Analysis of Appalachian's Proposal for Water Management

William Brush
Smith Mountain Lake Association
Tri-County Relicensing Committee

Presented to RRBAC
15 April 2008

RRBROM Model Results

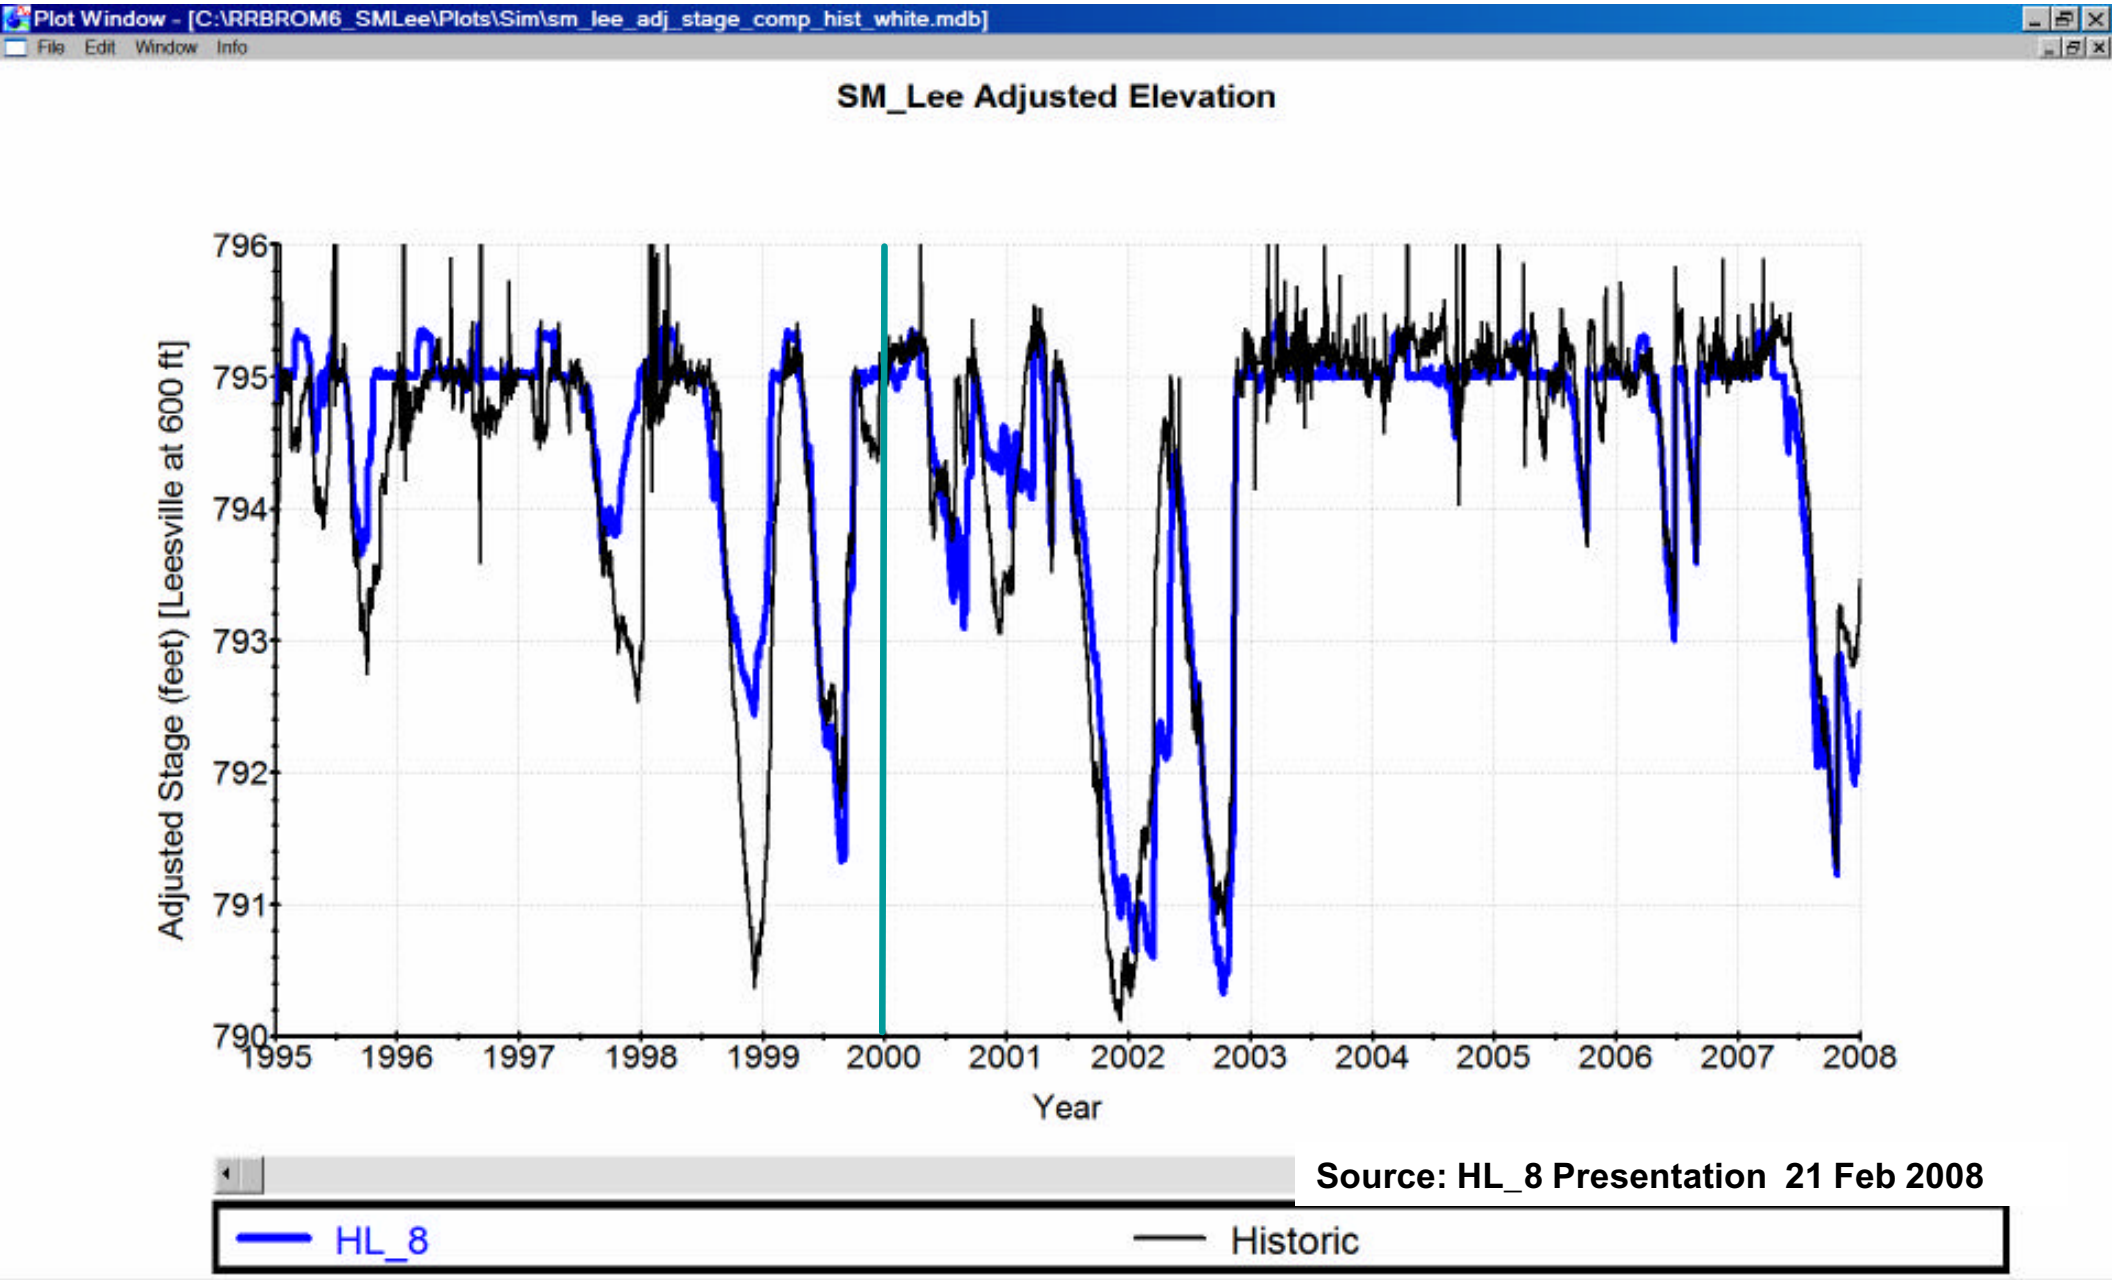
Public Safety Concerns

SML Actual Level = less 2' Power Pool

1. To Address Habitat Concerns …
   - Stream flow:
     - Move to continuous release from Leesville
     - Mimic natural hydrograph with releases
     - Striper release IAW DGIF floor
2. To Address Safety Concerns …
   - Project levels:
     - Safety floor of 792’ actual on SML
     - Protracted low flow periods 791’ actual

Navigation Aid B-13

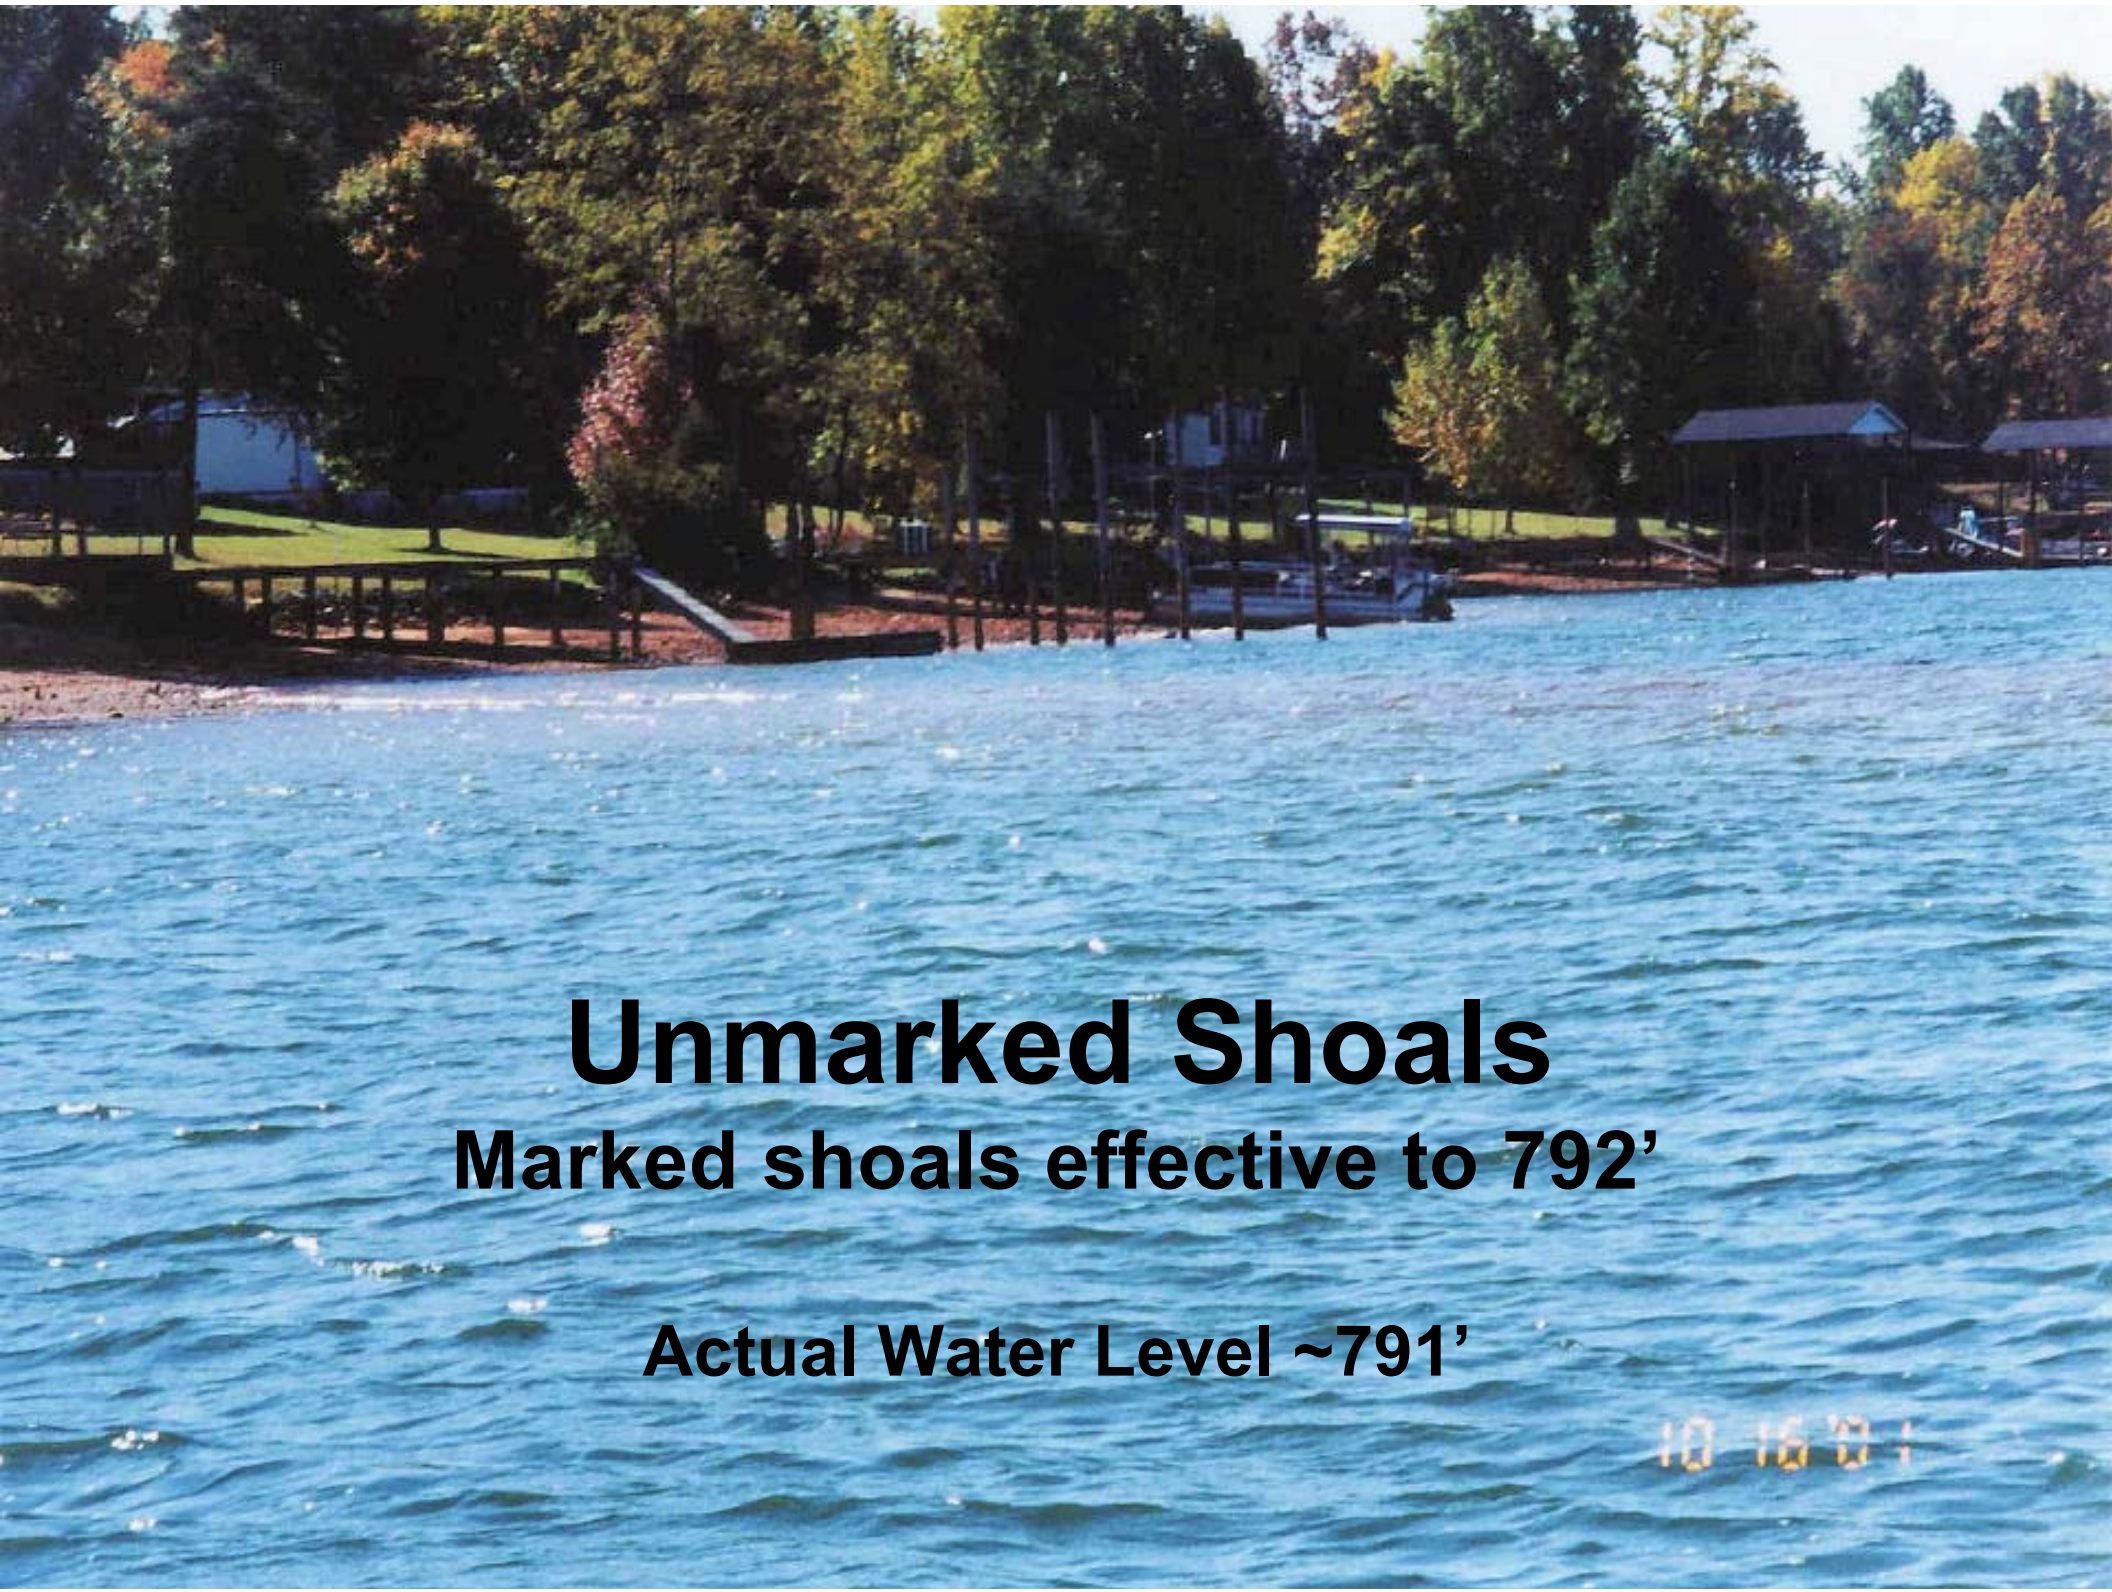
Effective to 790’ in Main Channel

Actual Water Level 790.5’

Unmarked Shoals
Marked shoals effective to 792’
Actual Water Level ~791’

Navigable Channels Narrow
Actual Water Level 790.5’

Why Not Follow the Natural Hydrograph ?

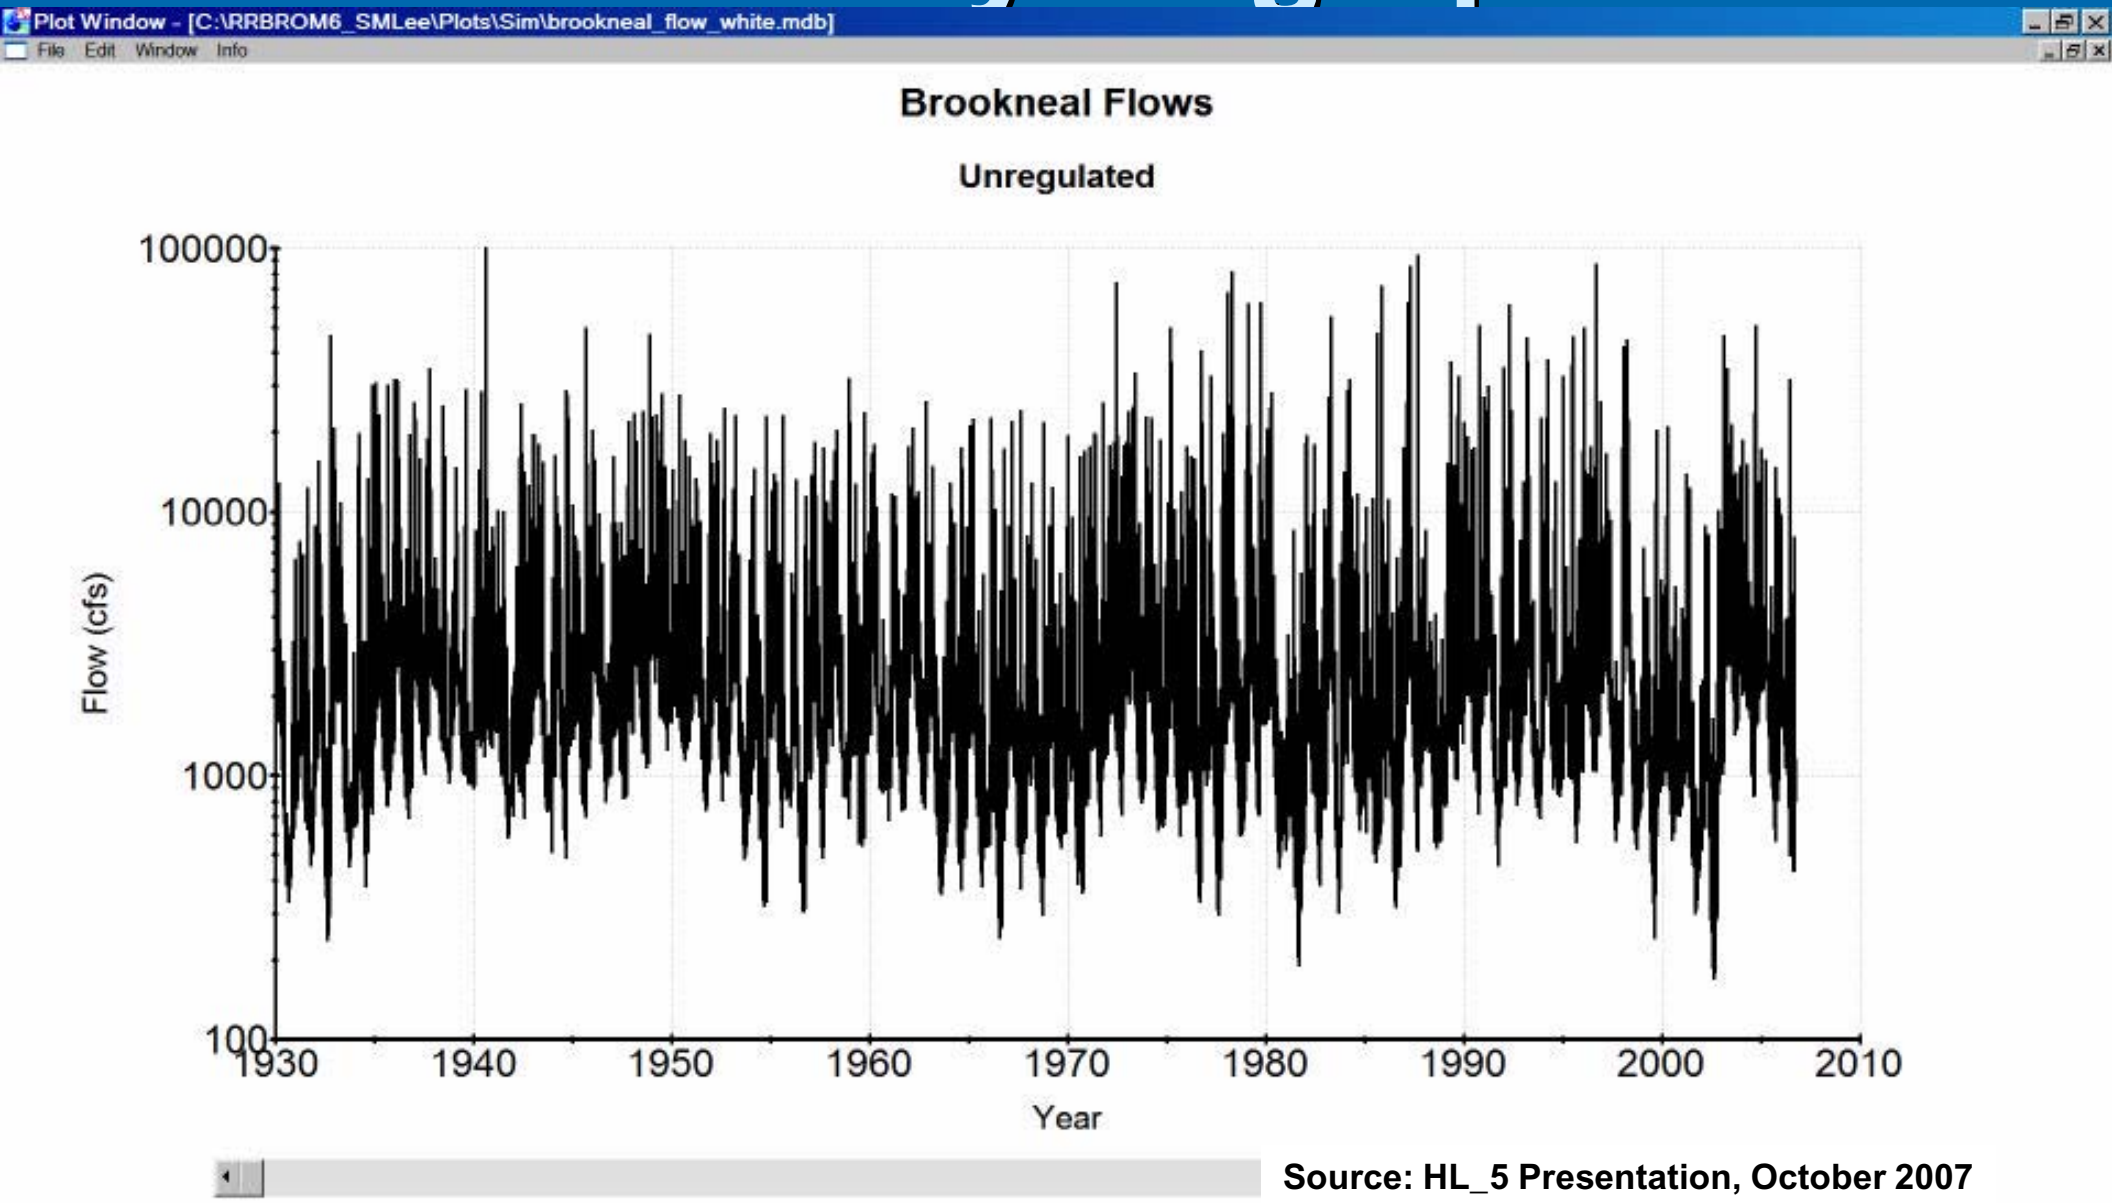
Mimic Nature's Flow Regimen

- Natural flow patterns result in sustainable, bio-diverse ecosystems
- Natural flow variation essential for a healthy river
- Scientist's do not fully understand interrelationships between flows, habitat and species diversity
- Wide-spread national scientific consensus
  - Nature Conservancy
  - In-stream Flow Council
  - American Rivers
  - Hydro Power Reform Coalition
  - Academia
